We included the original comments in black, followed by how we addressed them in the revised paper in green. We also included the most important comments and question from the annotated pdfs but considered all comments in our revision. We thank the reviewers and the editor for their constructive comments and suggestions.

Reviewer #1 - Juan Alcalde

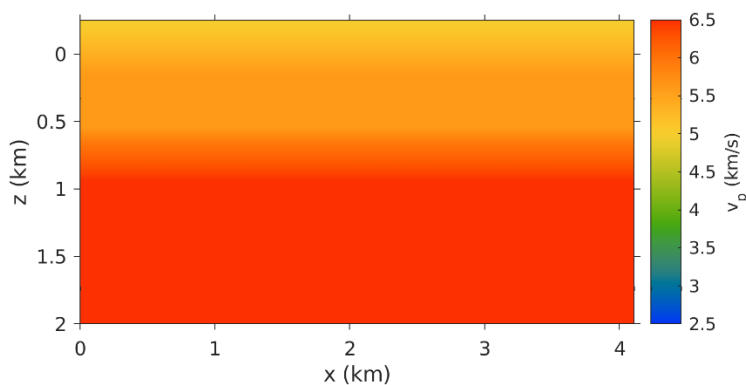
Same for the velocity model. It seems to be a very important input to achieve your final image, would it be possible to show a section of this model crossing the mineralisation to perceive the level of detail and resolution?

It is moderately important here; however, it is still very simple (1D gradient model), see the figure included below. Such an additional image would not show any important additional relevant information, so we decided not to include it. We included borehole logs in the geology section including p-wave velocities for the host rocks and the mineralization.
